Re: Site visits for boater access to the Chattooga Wild and Scenic River

Chattooga Access Site Visits

Figure 6: Trails lining River at Burrell's Ford.

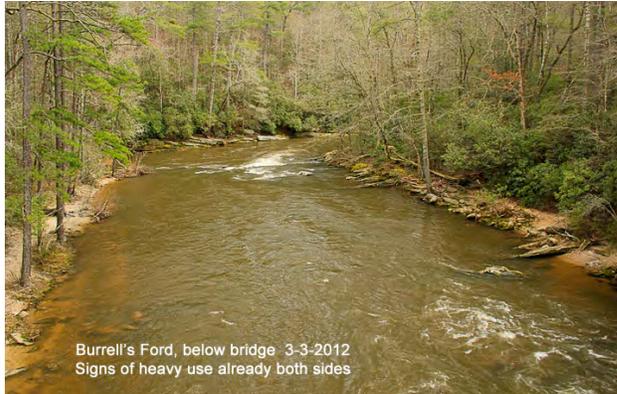
constructions, as already discussed. The only obvious access on the Georgia side is down a very steep and narrow user-created trail—nearly a ladder, to which the Forest Service has added some steps, several feet high each, to prevent severe erosion. The river ranger conceded that boaters would be unlikely to use this access, given other options.

User trails already line the riparian area near Burrell's Ford, and should be addressed.
